**Addendum No. 1**  
**January 13, 2023**

Project: Baltic High School Addition  
Baltic, South Dakots  
Arch Project No. 2957

Architect: Architecture Incorporated

**2.10**

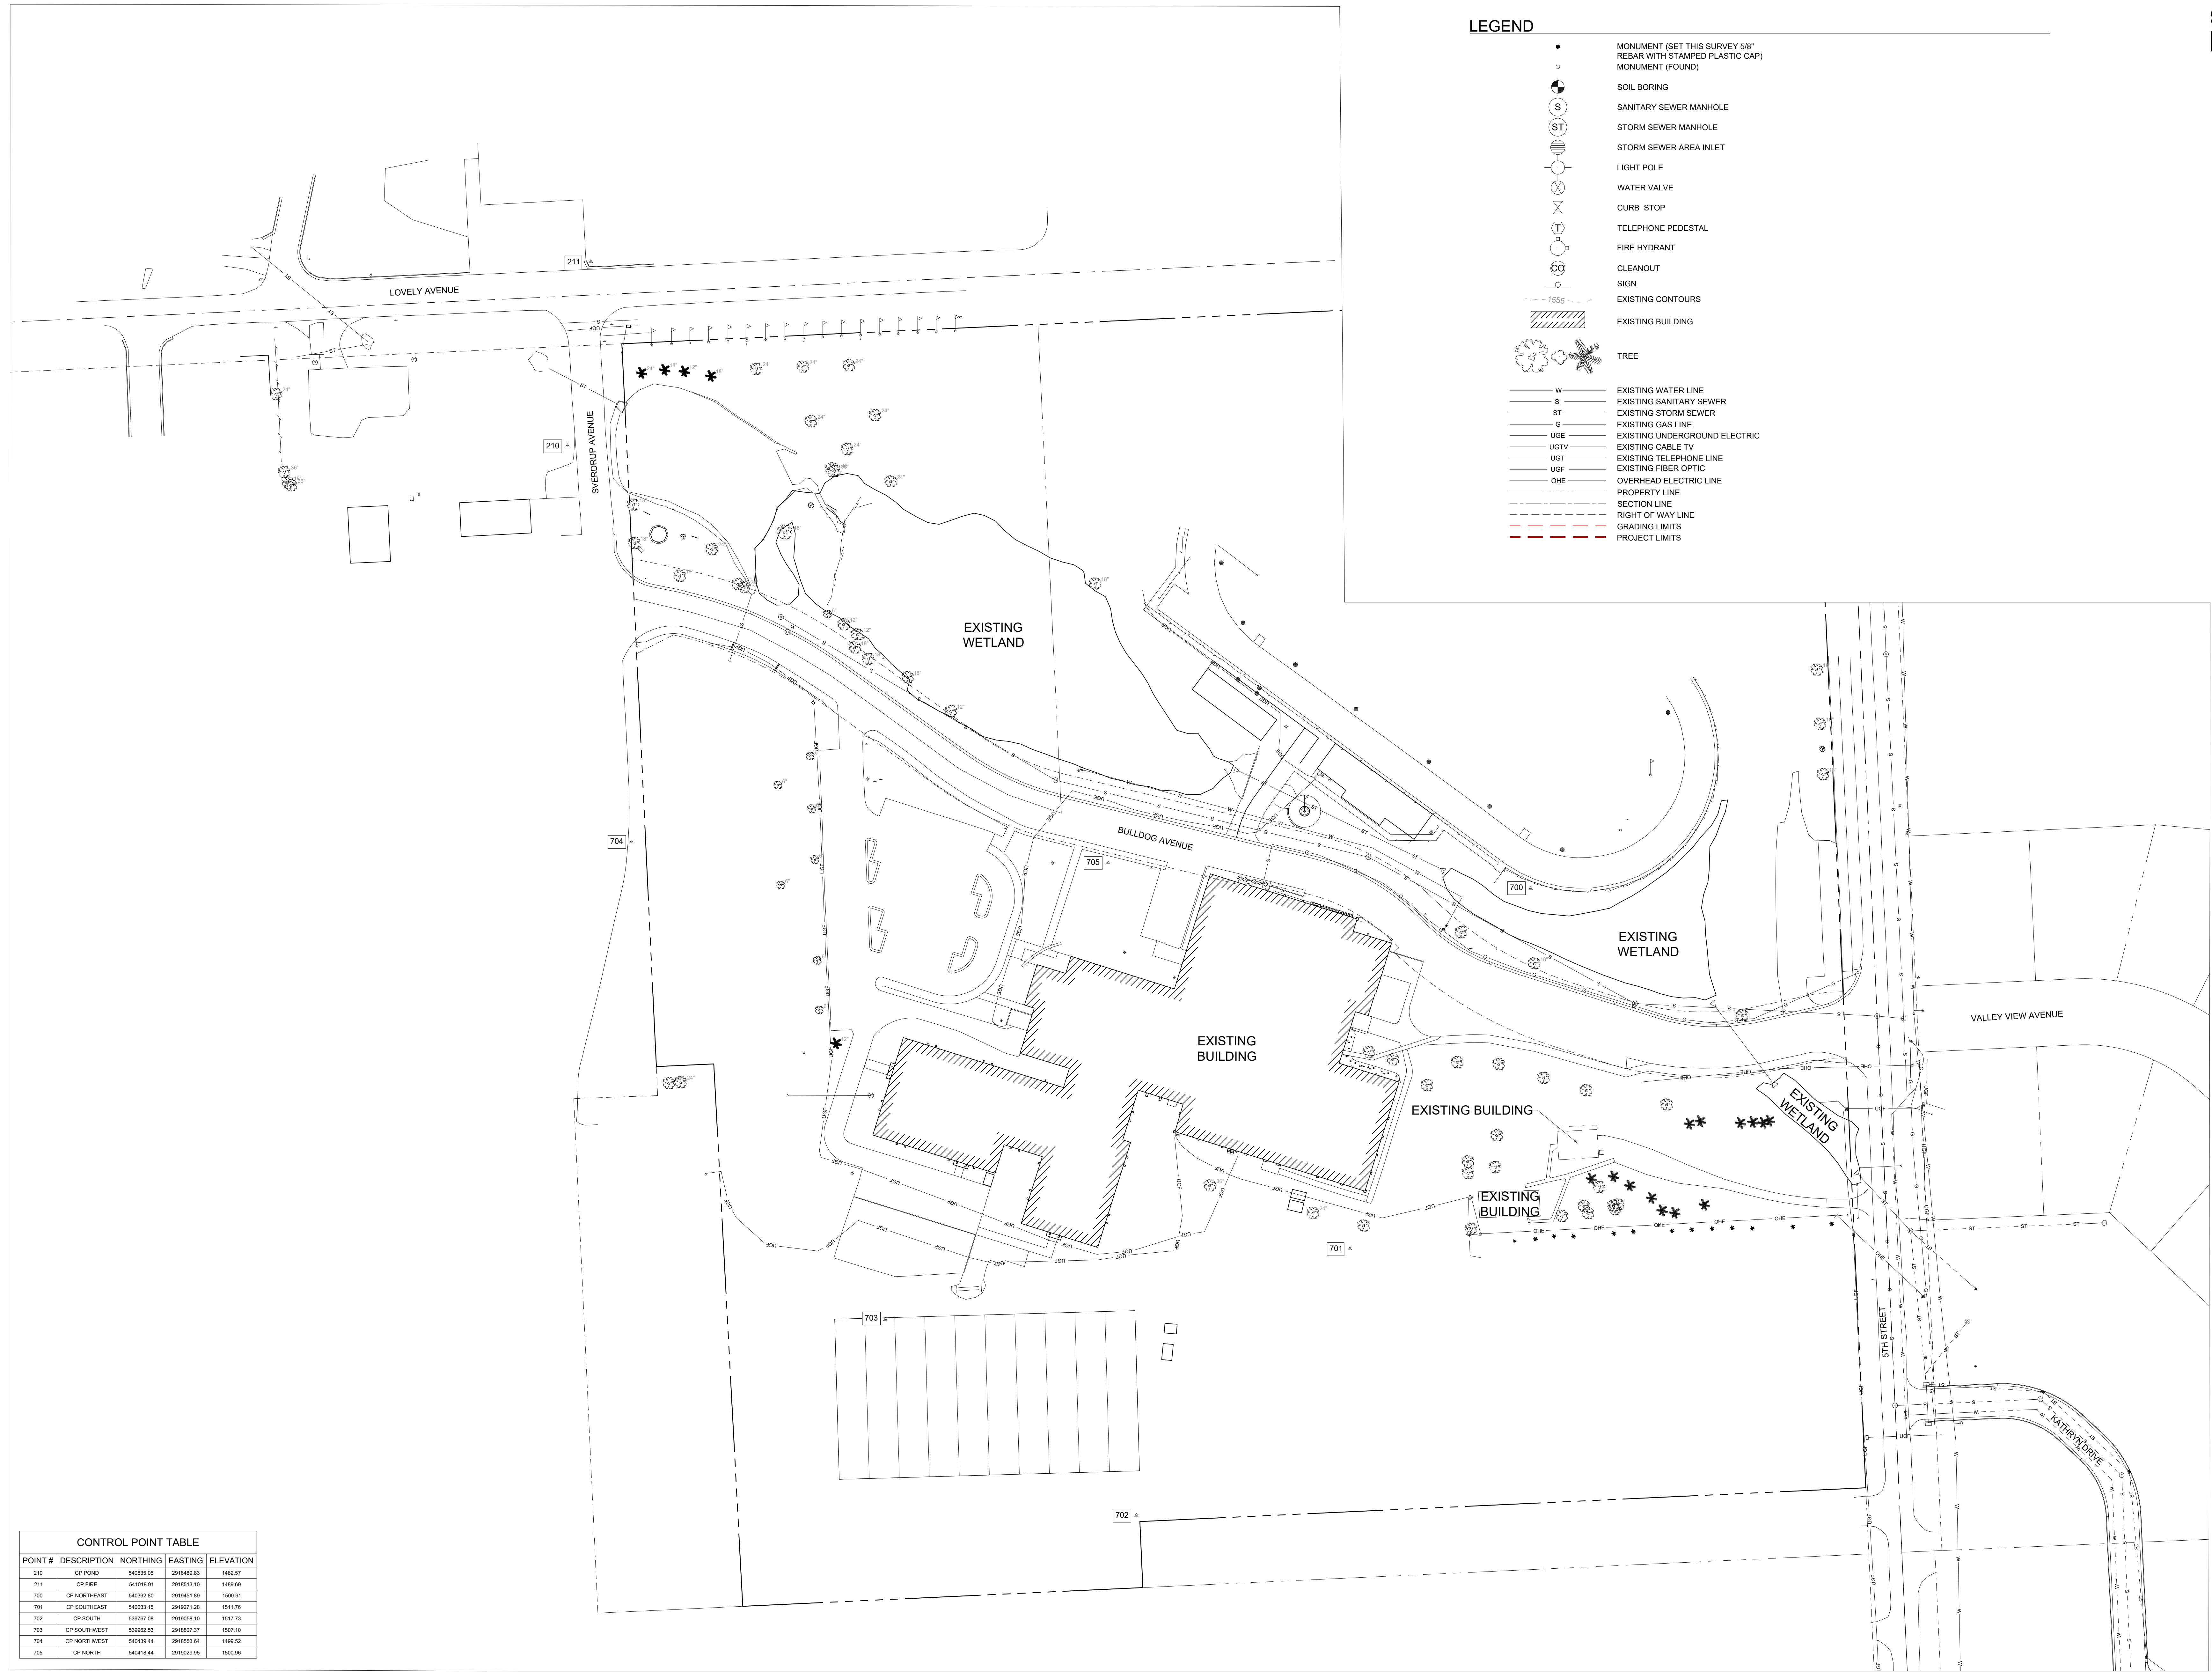
8) DRAWING 2.10 – SITE SURVEY

- a) The scale bar for this drawing Sheet has been updated / corrected; reference revised civil drawing Sheet 2.10 attached to the end of this addendum.

**2.50**

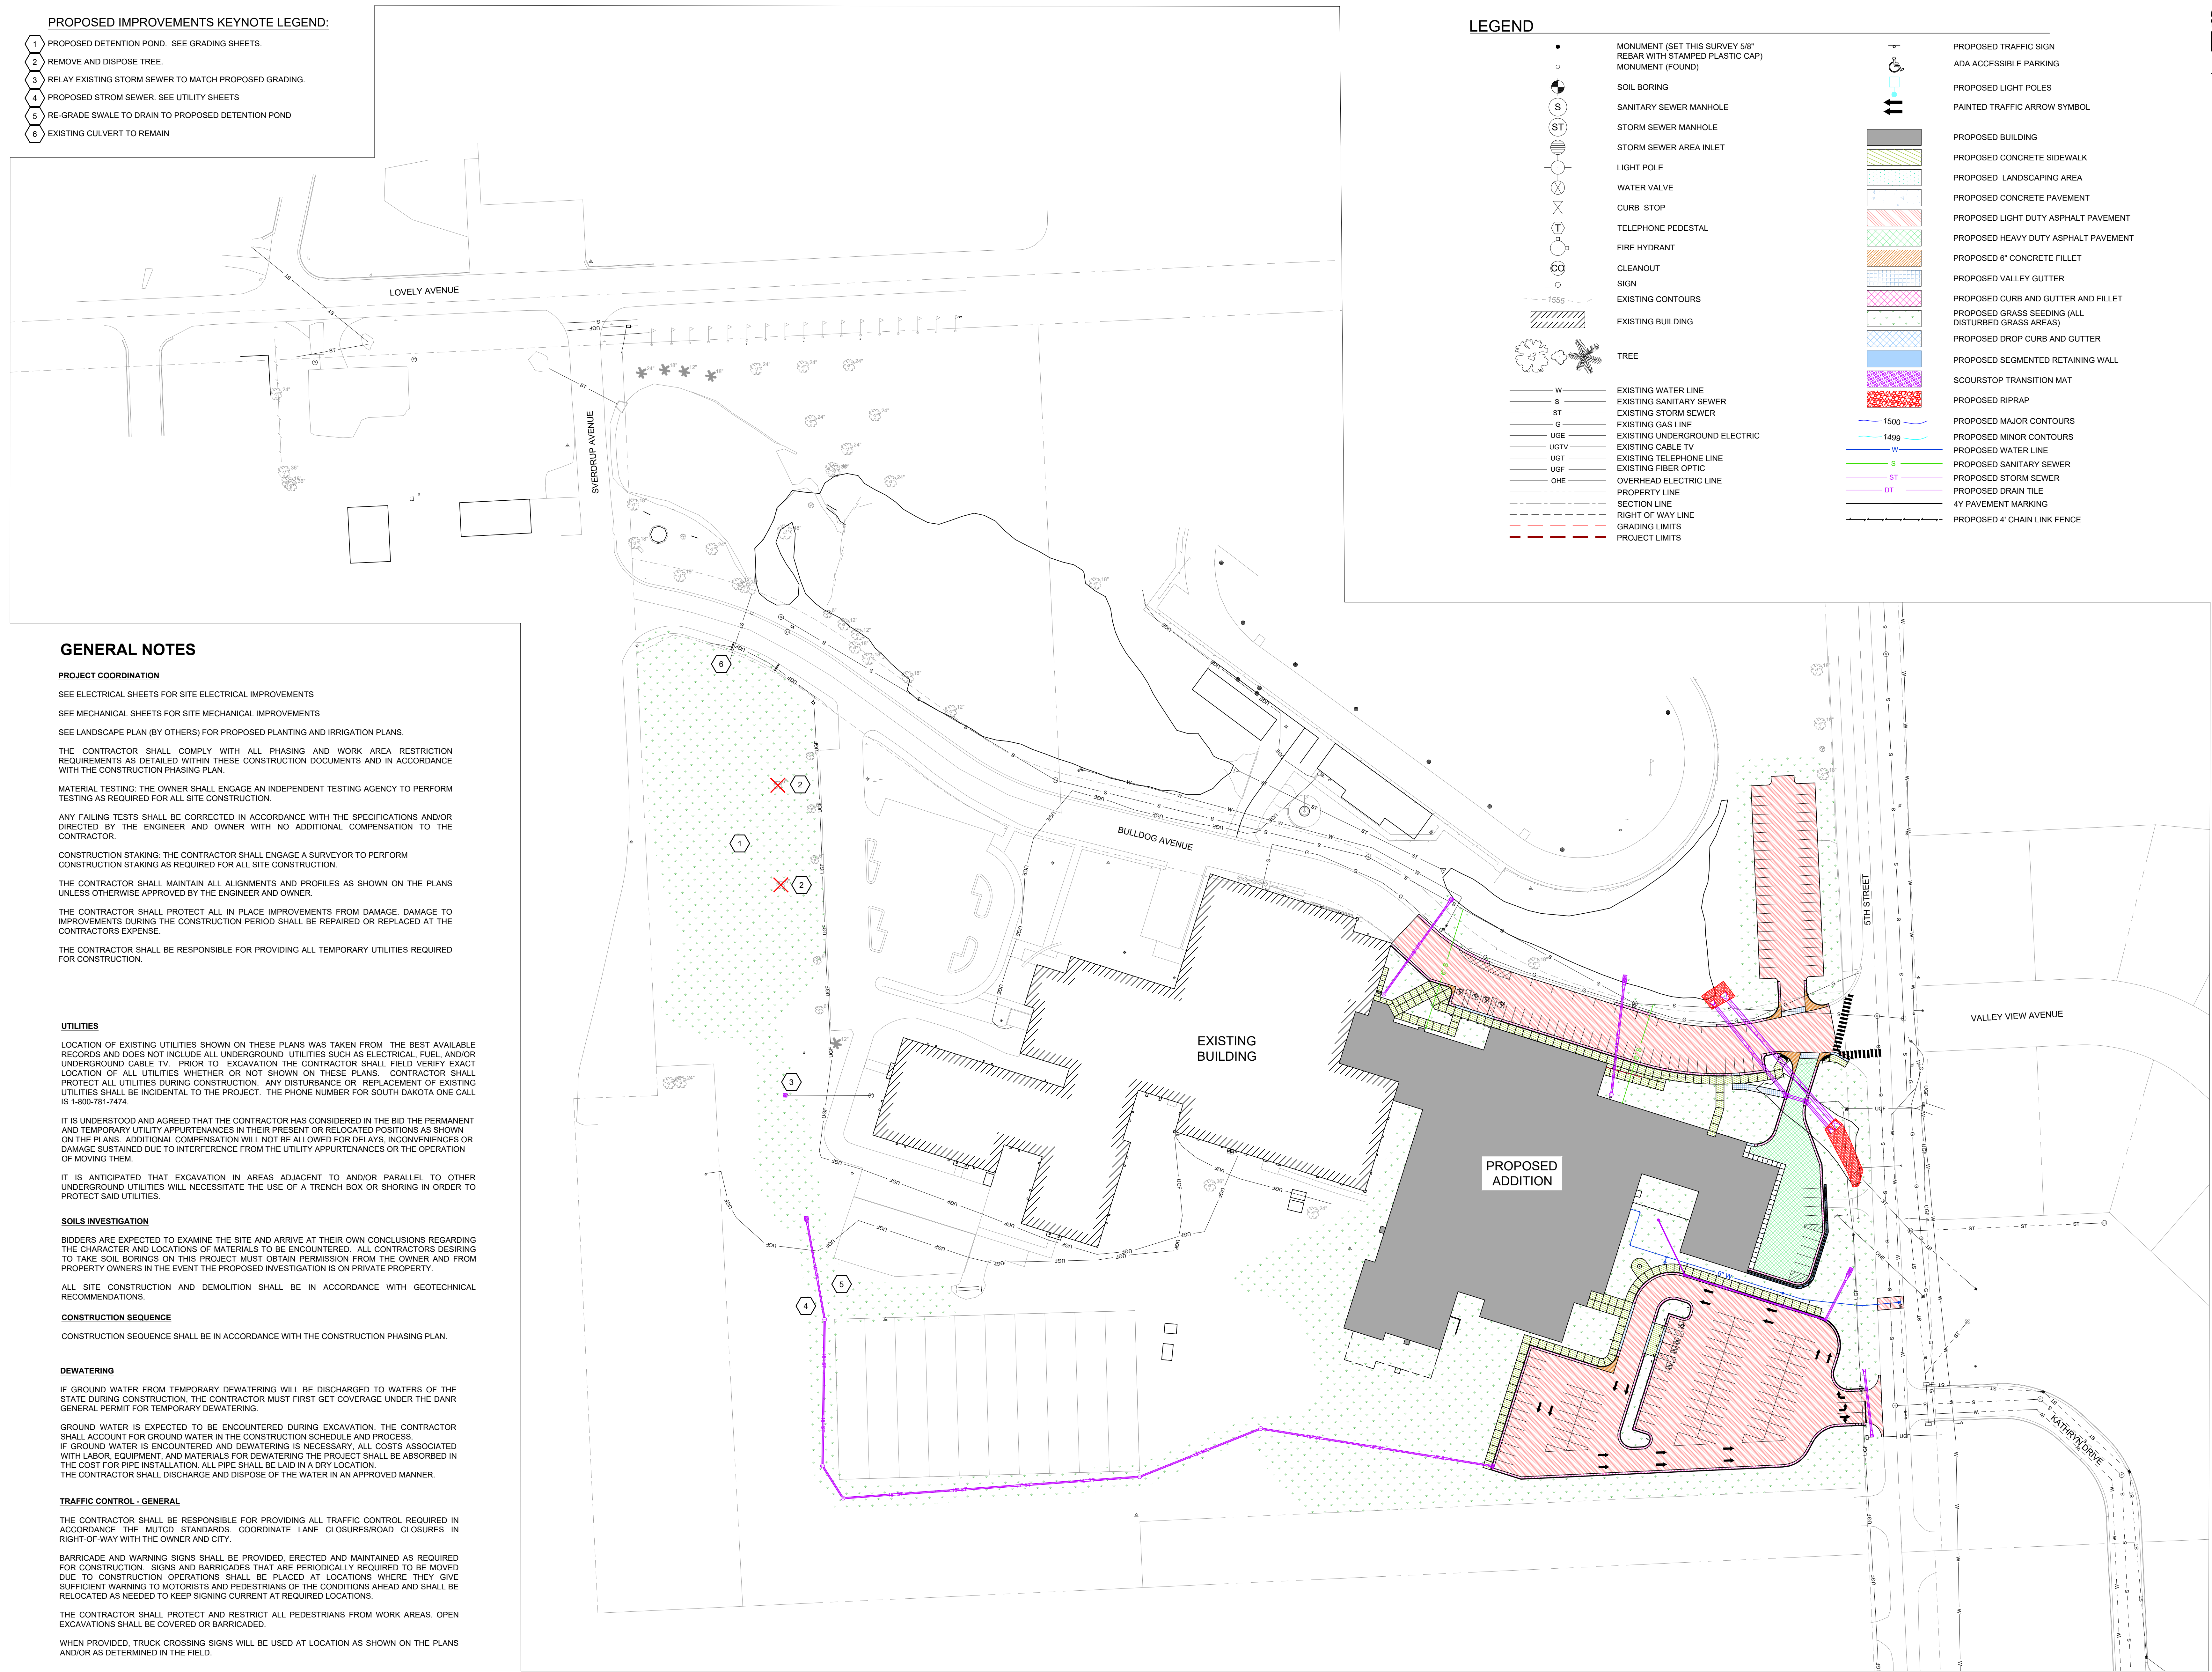
13) DRAWING 2.50 – OVERALL CAMPUS PLAN

- a) The scale bar for this drawing Sheet has been updated / corrected; reference revised civil drawing Sheet 2.50 attached to the end of this addendum.

**2.52**

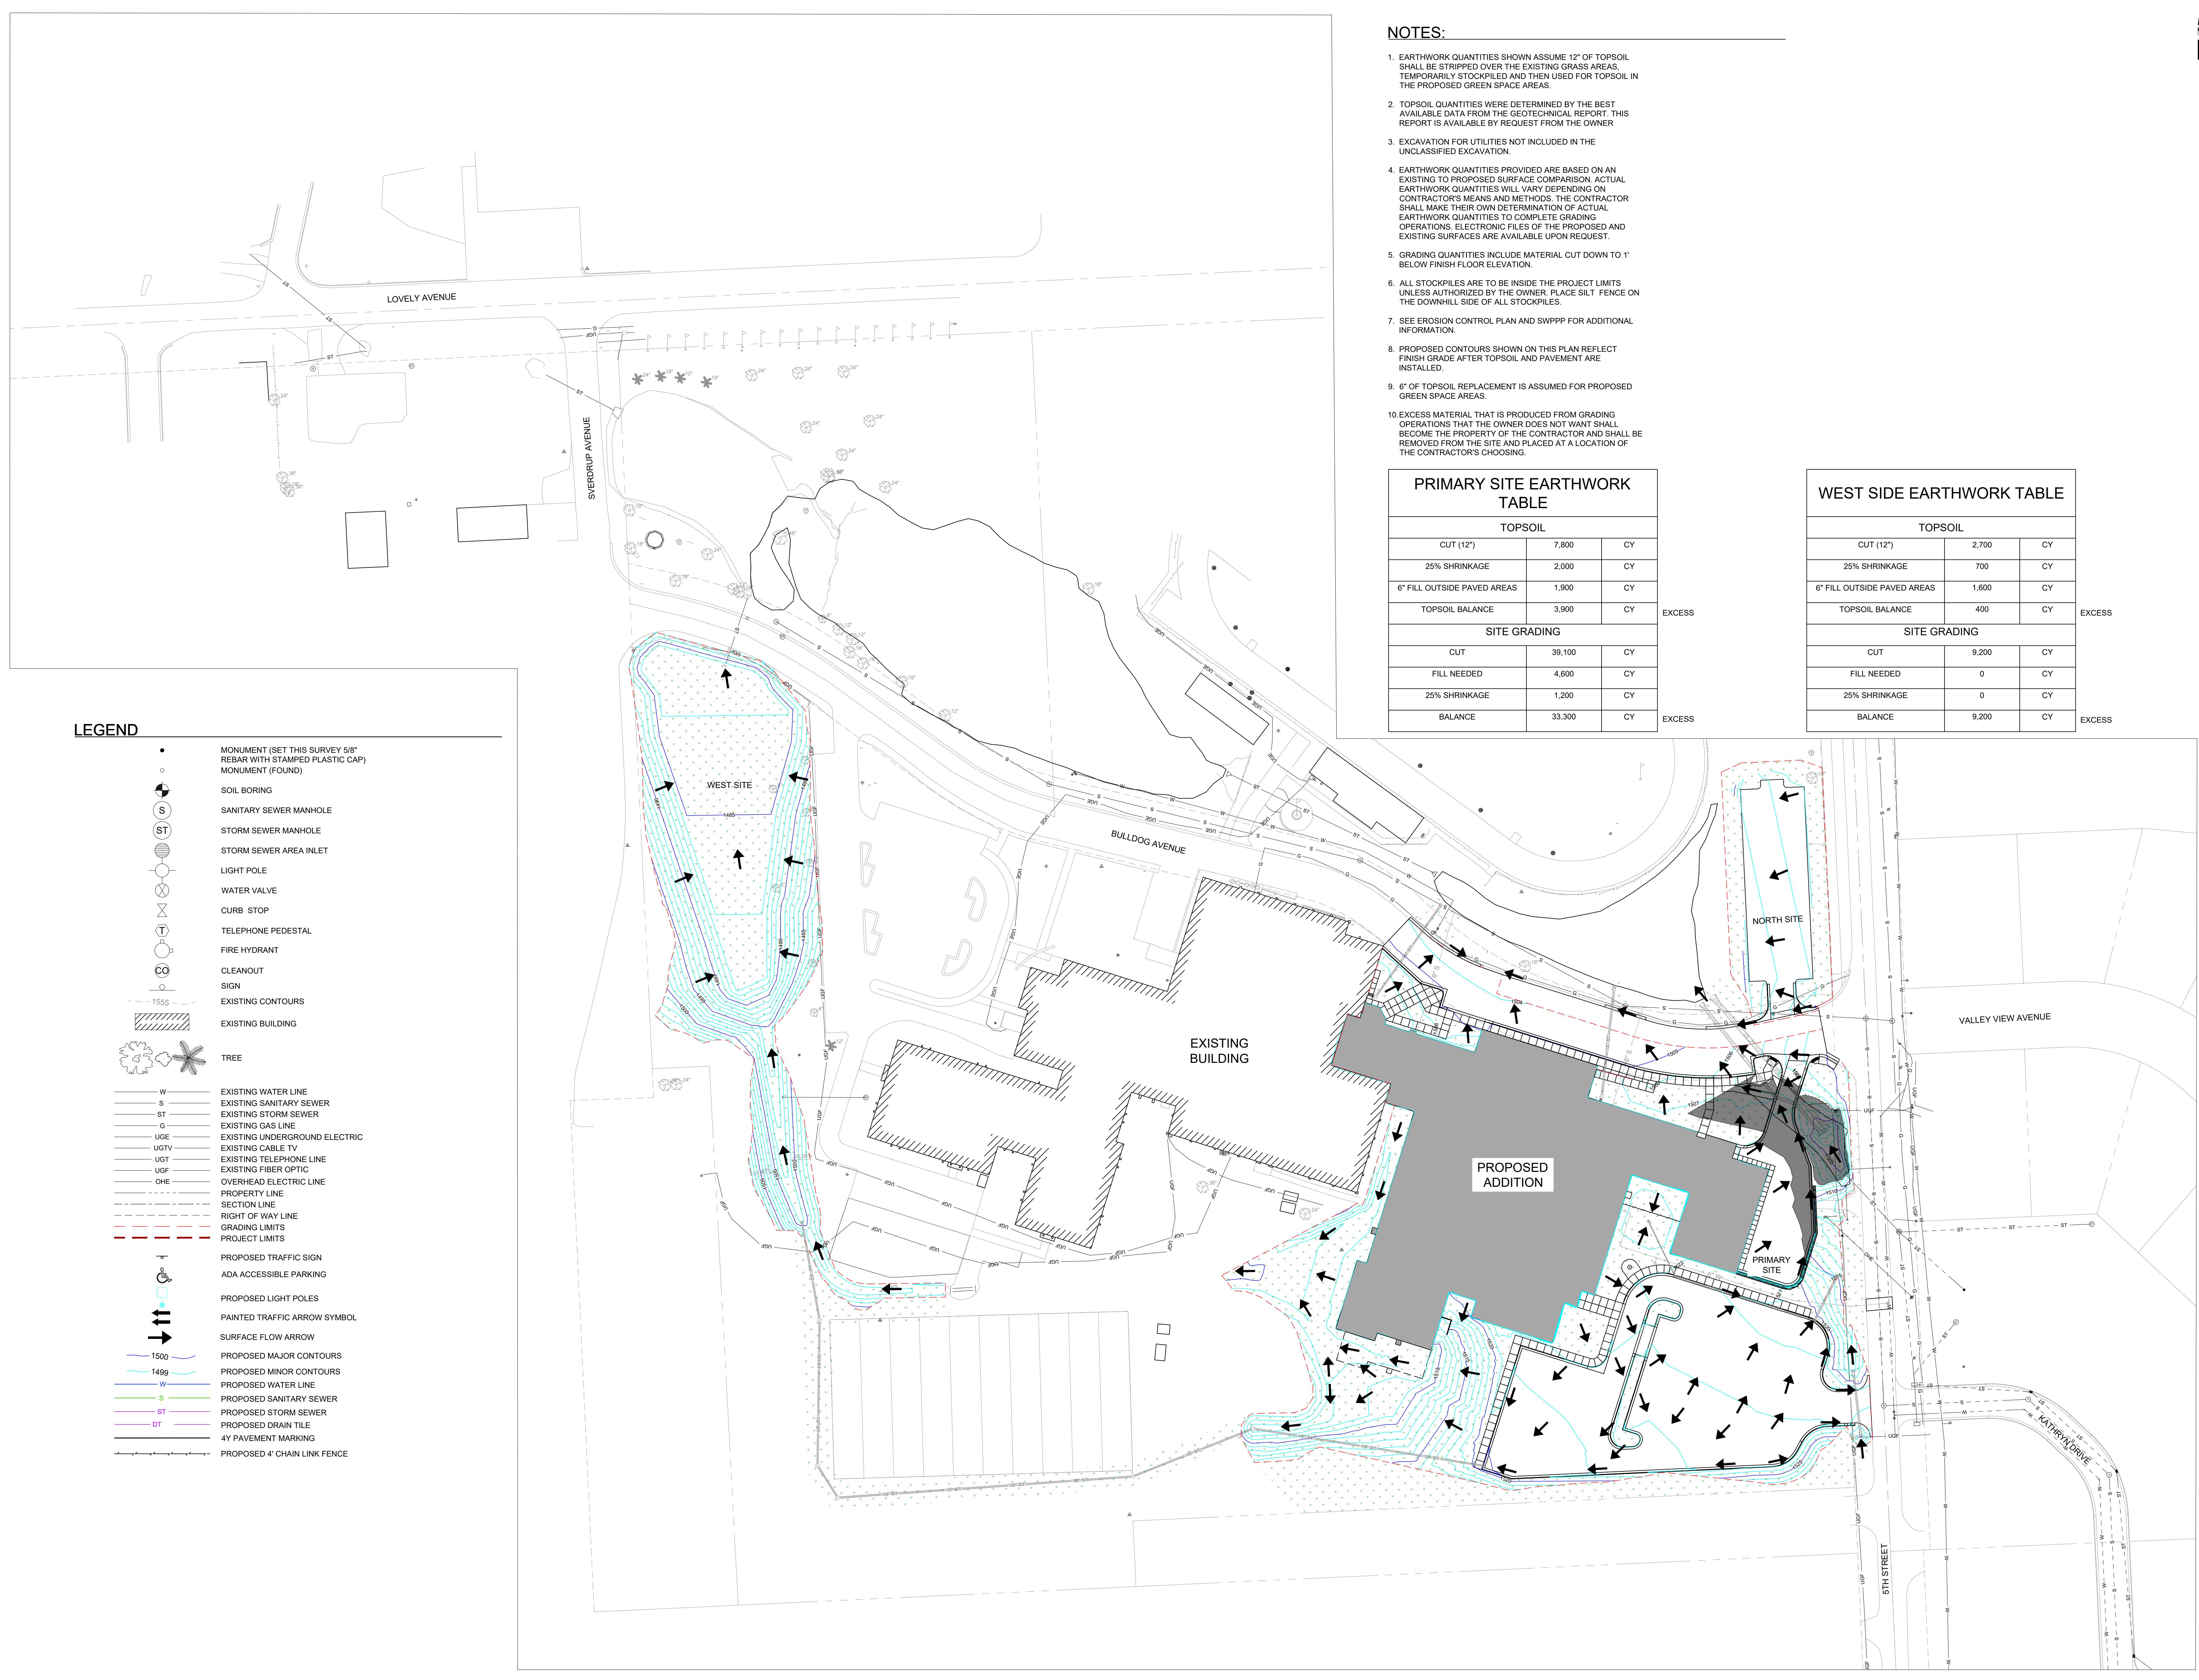
15) DRAWING 2.52 – OVERALL GRADING PLAN

- a) The scale bar for this drawing Sheet has been updated / corrected; reference revised civil drawing Sheet 2.52 attached to the end of this addendum.
